SERVICE BULLETIN

Number: 15-001

GM 6.6L Cable Connection Mandatory Product Improvement

Fig 1

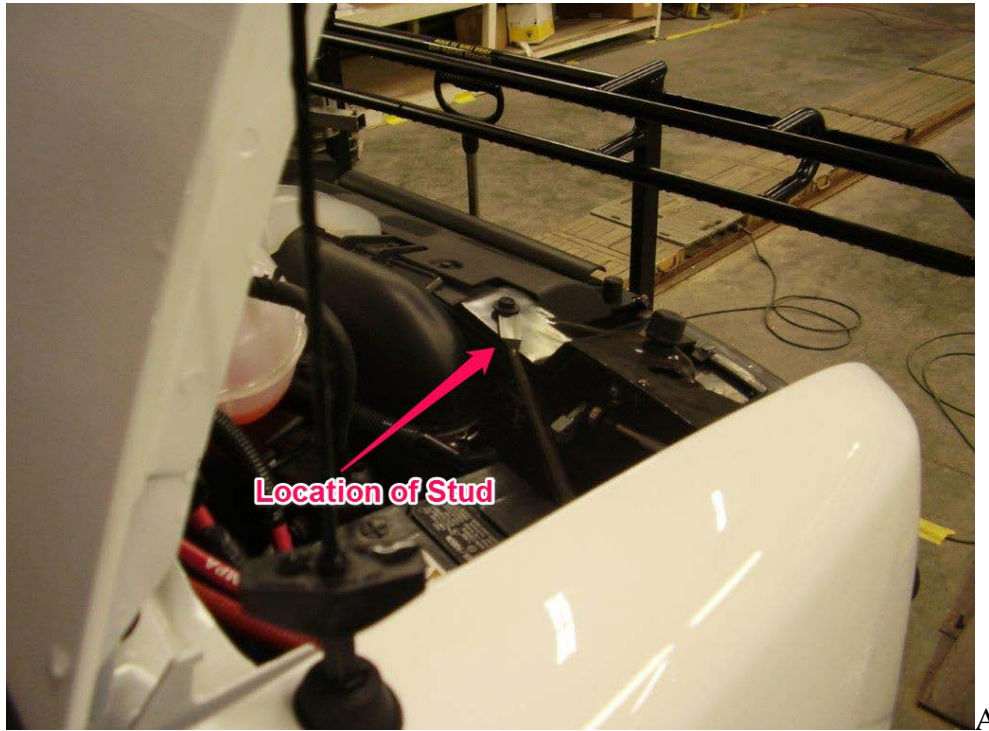
1. Open hood.
2. Locate the terminal strip (three studs) See Fig. 1 & Fig 2
3. Verify that the cable (blue) on the stud nearest the driver's side is secured correctly. See Fig. 3 & Fig 4

Inspect cable-to-stud connection. If the cable is angled (off vertical) over the edge of the terminal strip, loosen the self-locking nut and slightly rotate the cable to its proper vertical position, and tighten the nut securely.
